Site Address: 112A Great Russell Street, London W1B 3NP

Planning Application Ref 2020/3107/P: Removal/Variation of Conditions to facilitate a 208-bedroom hotel scheme, as a minor material amendment.

- 2.1 This Addendum report and by its terms, **an objection**, has been prepared on behalf of The Bloomsbury Association which represents a wide range of interests within the area surrounding the proposal, including business and residential interests.

Plan at Street Level

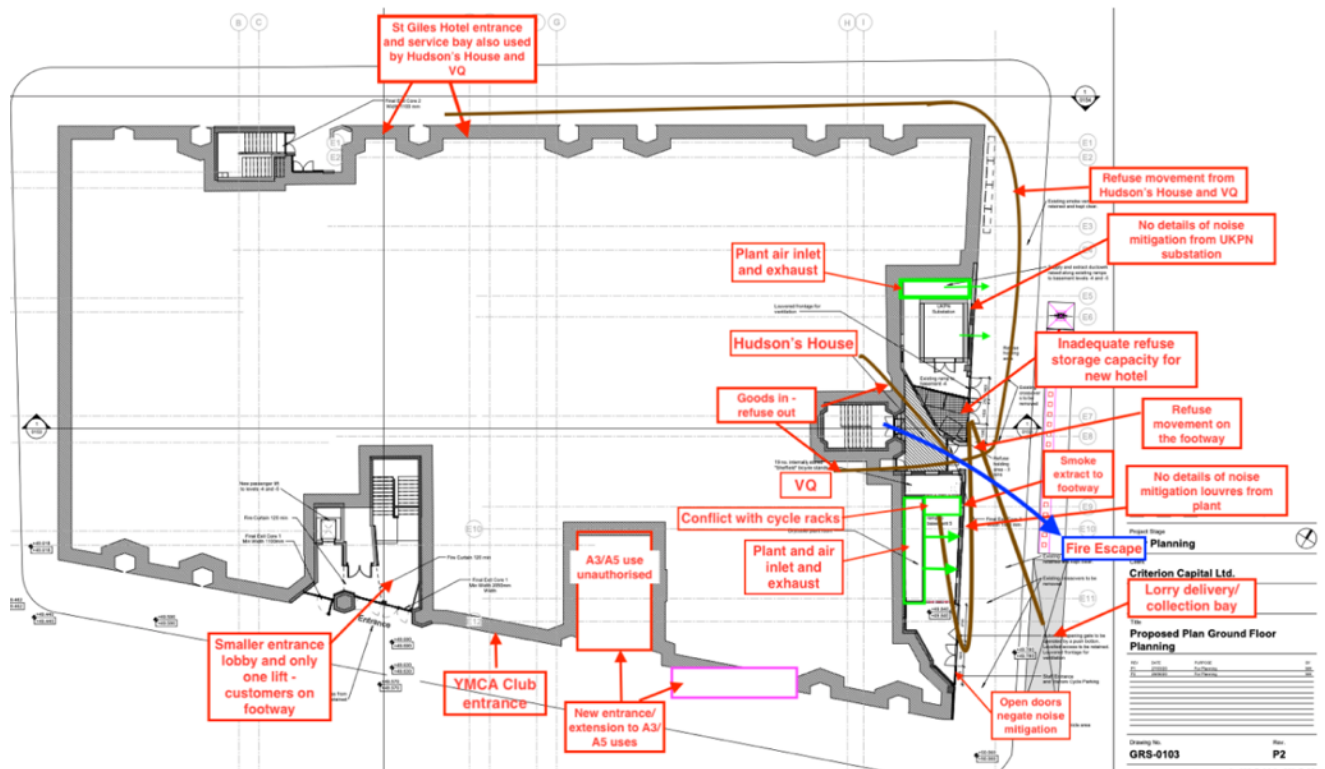
- 4.3 The refuse holding area clearly shows only three 1100 litre bins when this is insufficient provision. The Servicing Management Plan states, in Route for General Waste, item (b) on page 19: "*From there (level -5), the linen porter will move the trolleys to the EV at the foot of the ramp on level -5. The porter will then load the black bags onto the electric vehicle to drive these up the service ramp. He will then offload these from the EV and load these into the 1100l bins within the refuse store at street level.*" Clearly there is insufficient space in the refuse store for this to happen. Neither is it clear that 3-point turns can be achieved at the heads of ramps from levels -4 and -5 as claimed. The only way for the EV to get from the service ramp to the refuse store is via the pavement which may go to explaining why level access is to be maintained. The same process is repeated for other categories of waste, as described on pages 20-22. The design proposal is incompatible with the Servicing Management Plan, which cannot be implemented. The intention is clear: to store refuse containers on the public footway with the reassurance that Camden will not take enforcement action. The movement of goods in and out can only be achieved via the public pavement, all contrary to the Planning Inspector's expectations.

- showing adjoining uses and movement of goods and services in and out of the building on the pavement, rather than within the building as required by the Planning Inspector
